From: Shreekant Patel
Sent: 03 August 2026 11:48
To: Kwaku Bossman-Gyamera
Subject: RE: HGY/2026/1659 - Unit 28 Millmead Industrial Centre, Mill Mead Road, Tottenham, London, N17 9QU

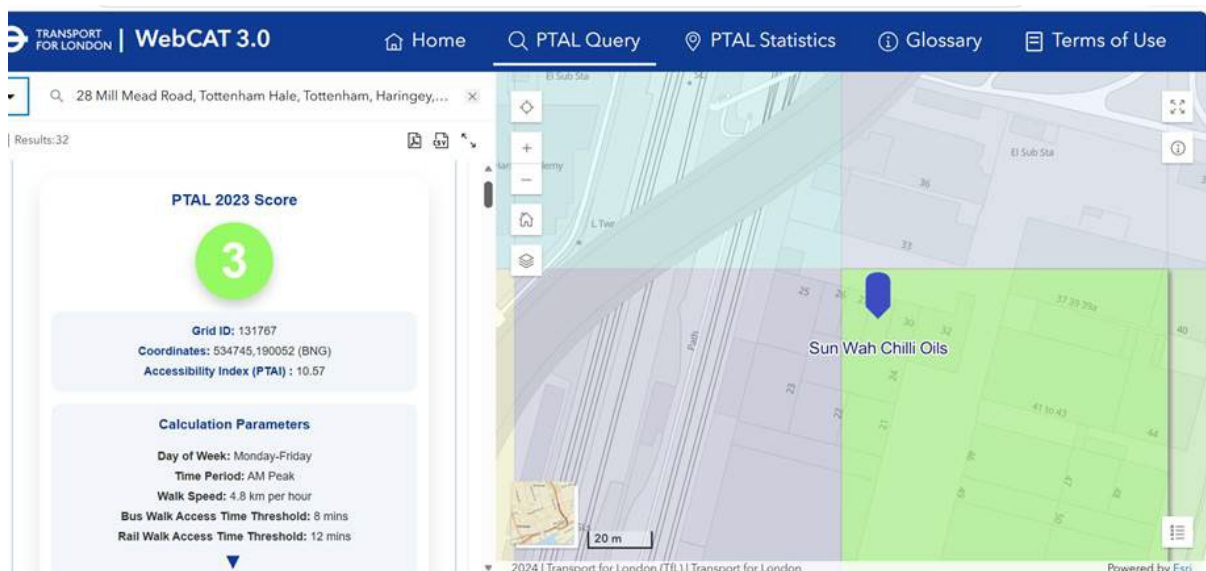
- a. The public transport accessibility for unit 28 is not as good (PTAL=4) as suggested. Please see extract below that indicates that Unit 28 is very closer to area with PTAL=1b than 4:
